REMARKS

METHOD AND DEVICE FOR THE CALIBRATION-EQUALIZATION OF A RECEPTION SYSTEM

Application No. 10/669,691
Inventor: Pascal CHEVALIER et al.

FIG.1

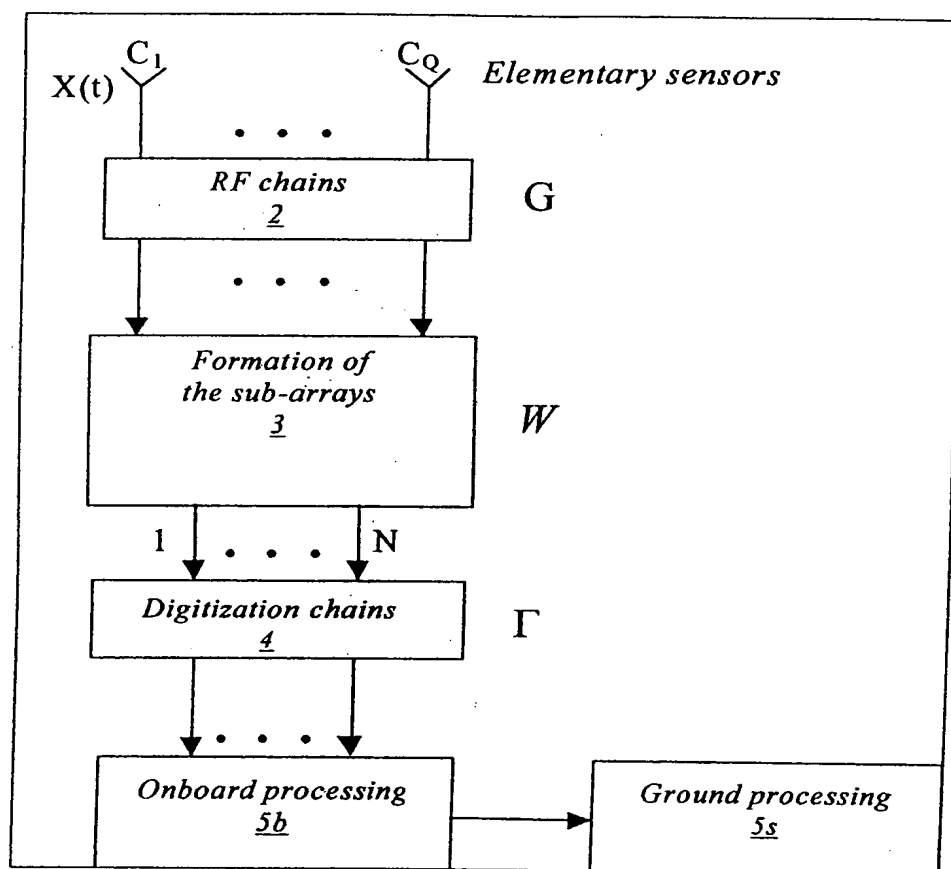
Figures 1-5 were objected to as not being designated to by a legend such as "Prior Art". In response, attached to this Amendment are Annotated and Replacement drawings for Figures - 1-5 designated as "Prior Art". Accordingly, this objection should be withdrawn.

~~PRIOR ART~~

FIG.3 PRIOR ART

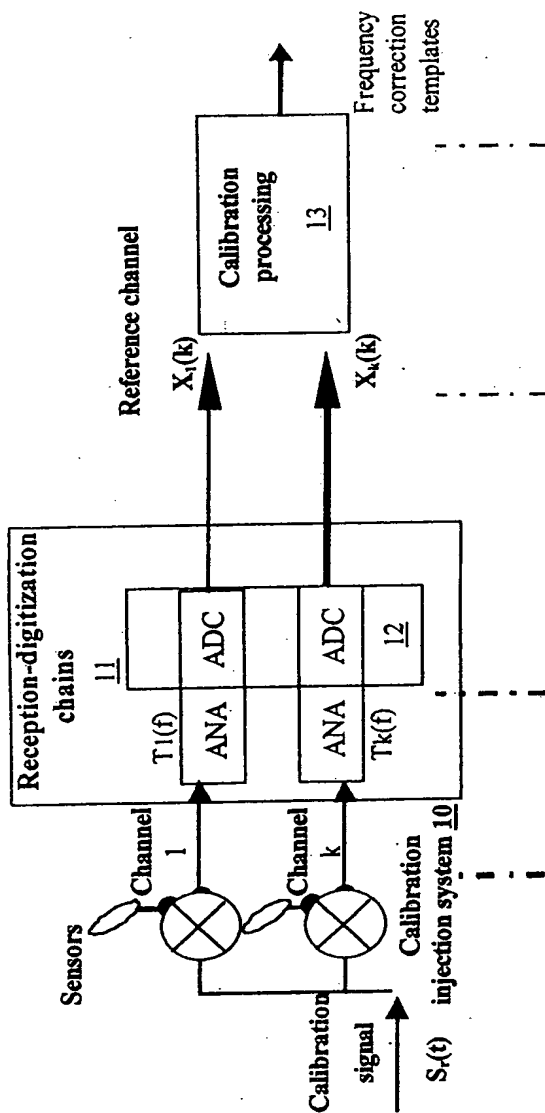
Applicants mention example of way to overcome the limitations in paragraph "C-Equalization of the reception chains". For example, Figure 3 shows a classically used generic calibration system. This system uses a "classically, a switch-based system is used" and fails to describe the characteristics of claim 1 of the present invention.
